**BEFORE THE PUBLIC UTILITY COMMISSION
OF OREGON
UM 1657**

PORTLAND GENERAL ELECTRIC
COMPANY

Smart Grid Report

STAFF'S COMMENTS

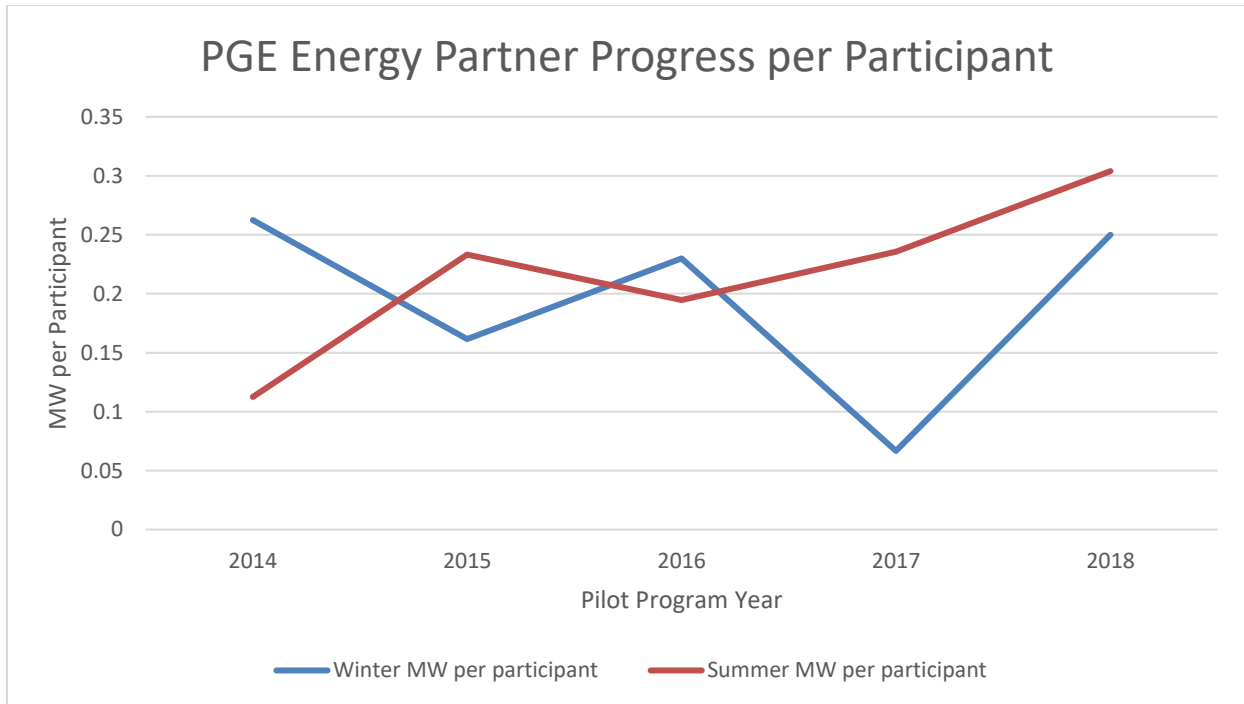
When depicted as a reduction in megawatts per participant, this pilot program shows a big drop in its 4th winter.

Staff would like to see a detailed explanation for this drop in winter 2017. The 2019 Report says something similar to the last report – that the results dropped because “loss of customers to direct access and poor event realization rates caused nominated commitments to drop below 8.5 MW in subsequent months.”⁶ Tracking this pilot in MW per participant helps control for the reduced participation, but Staff would like to know why there was “poor event realization” in that year and what specific lessons were learned to avoid it in the future. And what caused the need to restate the 2017 results down to 3 MW from what was reported in the *2017 Smart Grid Report*?
